Response to ABP Opinion

Planning Application

Cúirt Na Coiribe,
Headford Road,
Terryland,
Galway,
County Galway

RE: APPLICATION FOR PERMISSION FOR DEVELOPMENT OF HORIZONTAL AND VERTICAL EXTENSIONS TO THE EXISTING STUDENT ACCOMMODATION COMPLEX AT CÚIRT NA COIRIBE, HEADFORD ROAD, GALWAY, INCREASING THE QUANTUM OF BEDSPACES FROM 405 NO. TO 920 NO.

Figure 3.2: Design Changes to the Subject Scheme

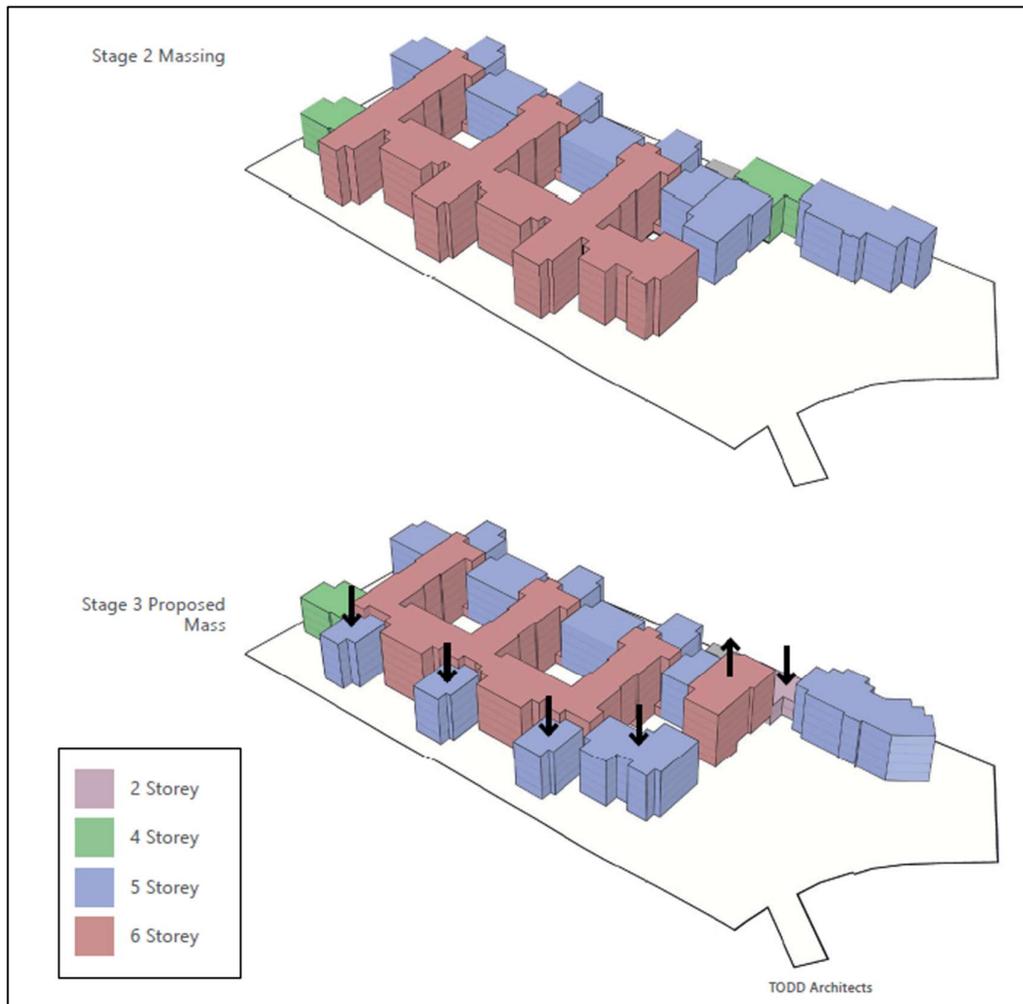
'Further consideration of the design strategy and overall layout of Blocks 8 and 9 adjacent to the adjoining north-east boundary and blocks 3 and 4 adjacent to the western boundary, having particular regard to scale, massing, overlooking, and the relationship of these proposed blocks with established and potential future amenities of the neighbouring sites at these locations. The further consideration of these issues may require an amendment to the documents and/or design proposals submitted at application stage.

As demonstrated in Figure 3.2, there has been a reduction in height (1 No. storey) to several of the extension blocks, especially along the south-western boundary. The segment of Block No. 8 closest to the north-eastern boundary has also been reduced in height from 4 No. storeys to 2 No. storeys.

Figure 4.4: Proposed Materials of the Subject Design

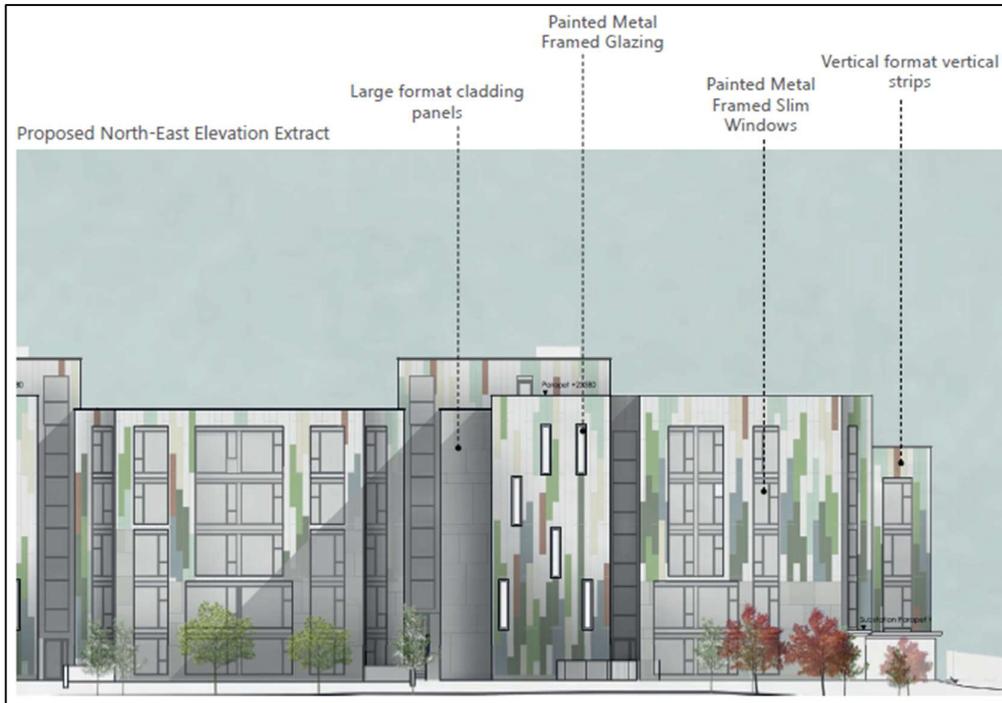
'A report that specifically addresses the proposed building materials and finishes and the requirement to provide high quality and sustainable finishes and details.'

'The current palette of materials principally consists of painted rendered external walls, with some feature limestone-clad elements, and pitched roofs, all of which seems appropriate for the scale of development. However, we are of the opinion that a more sophisticated palette of materials is merited in the proposed enlarged development.'

'The entire external appearance of the development will be significantly upgraded both in visual and thermal performance terms and there will be no difference between the existing buildings and the newly constructed elements.'

'Rain screen cladding board is proposed for the whole development as a sustainable solution as it is made from recycled content and has a low embodied energy due to it being manufactured in Ireland. Rain screen also has a high insulation value as it allows for insulation to be placed on the exterior of a building – minimizing thermal bridging. It also can reduce heating and cooling costs of a building as the ventilation gap between the panel and insulation materials allows excessing heat & cold be dissipated. Rain screen cladding is also low maintenance with a long life expectancy.'

Figure 4.8: Changes to the Proposed Design. Note Block No. 8 along the north-eastern boundary which has reduced to 2 No. Storeys.

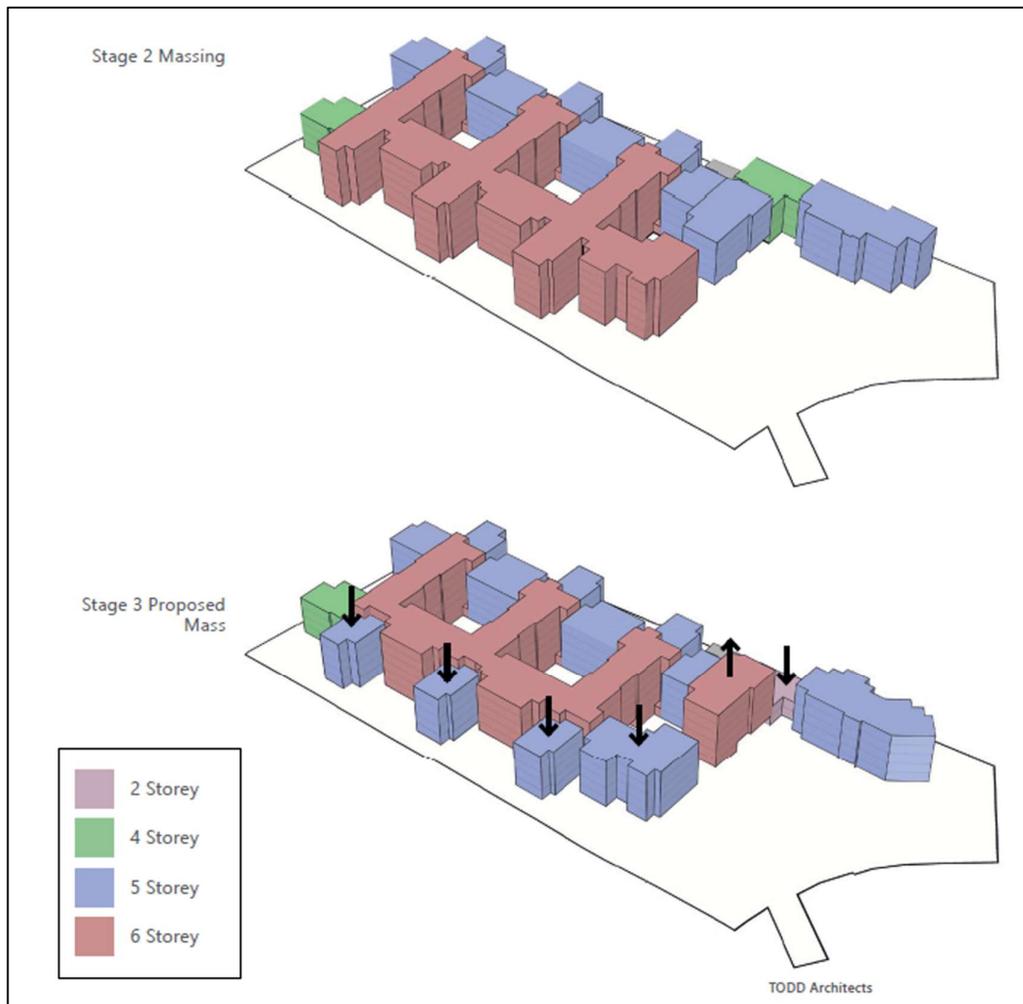
'A report that addresses issues of residential amenity (both existing residents of adjoining development and future occupants), specifically how the development will limit the potential for overlooking, overshadowing and overbearing. The report shall include full and complete drawings including levels and contiguous site cross-sections and elevations showing the relationship between the proposed development and adjacent developments.'

This has seen an improvement in the Vertical Sky Component (VSC) achieved by the assessed windows of properties within Gort Na Coiribe compared to the pre-application design. This has been accomplished through the reduction of heights in some locations, such as Block No. 8, and changes in the massing of the proposed Block No. 9.

'Of the 182 windows assessed for impact to VSC, 178 have met the BRE guidelines on impact to VSC. The impact to these windows would be considered imperceptible. All 4 windows that did not meet the BRE guidelines on impacts to VSC would encounter a slight level of impact.'

This demonstrates that through a reduction in heights and a modulation of the proposed design there has been a reduction in impacts on the VSC reaching neighbouring developments. A total of 13 No. windows have seen a reduction in impact as a result of changes to the proposed design.
